COMMENTS ARAL KIREMIT (TURKEY) 240123.

DIRT ON THE BOTH SIDES OF THE PALLETS:

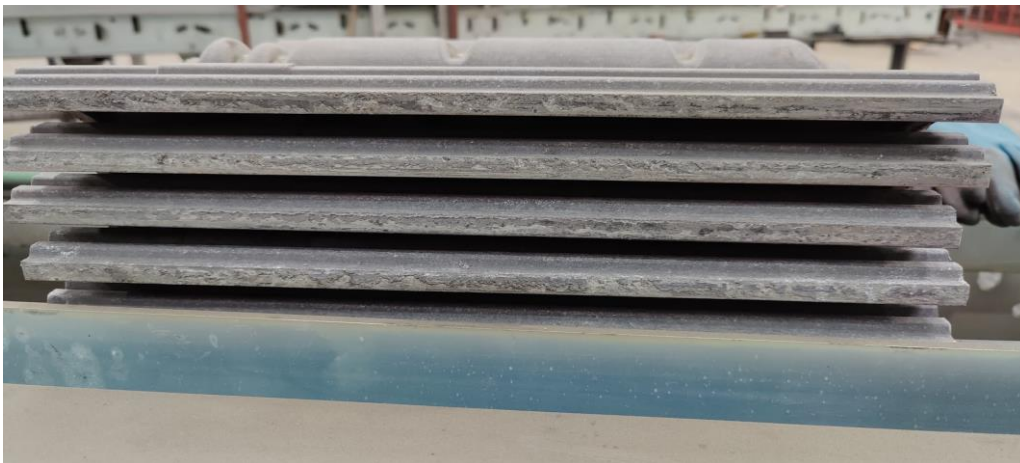
We continue with the lateral dirt of the PALLETS, I confirm that there are cleanings by the lateral scrapers in the conveyor of entrance to the extruder, it is not enough.

On these 2 scrapers it cleans more residues in the interlocking area than in the overlocking area, I suggest to clean the sides of the pallet at the extruder outlet

The lateral guide at the extruder outlet on the overlocking side was replaced because it was broken, in this position in my opinion, although insufficient, it is cleaning the side of the mould with its friction.

On the other hand, the other guide in interlocking I think that the level of dirt is the same or worse because of the entrance of the guide.

In my opinion, a side scraper should be placed at the extruder outlet or after cutting, on both sides after cutting, with a thin and constant blade.

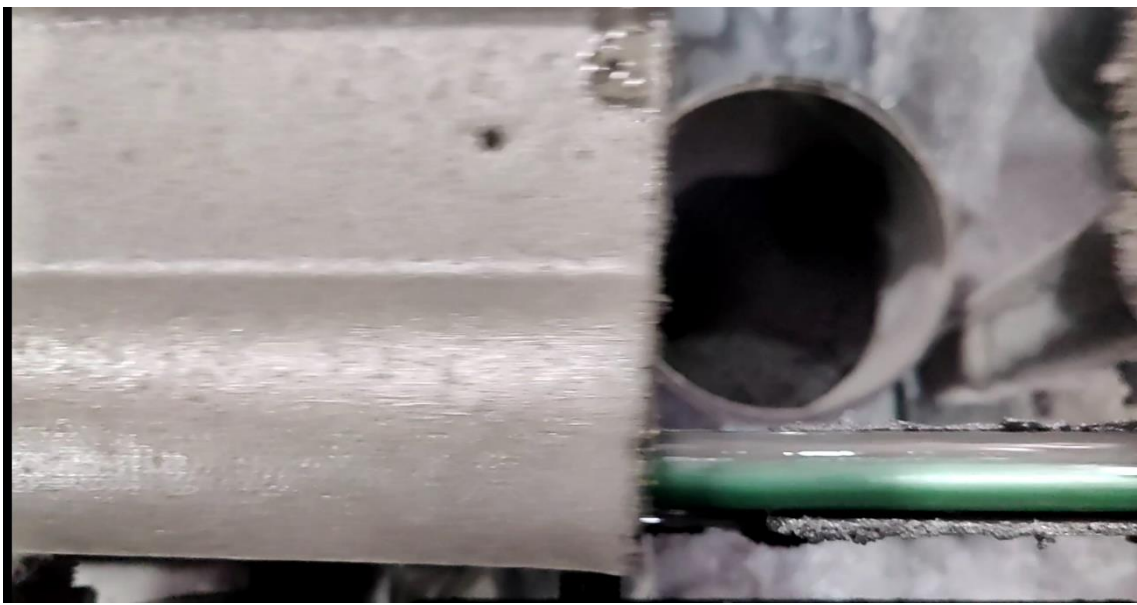
The production on the 17th, 18th and 19th of January was very stable, with the consumption of the pallet advancement and the roller remaining stable, with **16.5 A / 16.2 A** on the pallet advancement and **11.3 A / 11.4 A** on the roller.

On the 16th of January until the adjustment of the sand or sand and water mixtures the consumption was **29 A / 23 A** at the pallet advancement and **25 A / 17 A** at the roller.

On the 19th of January when I left, the production at 20:00 was 19.910 tiles and the consumption was **16,5 A** for the pallet advancement and **11,5 A** for the roller.
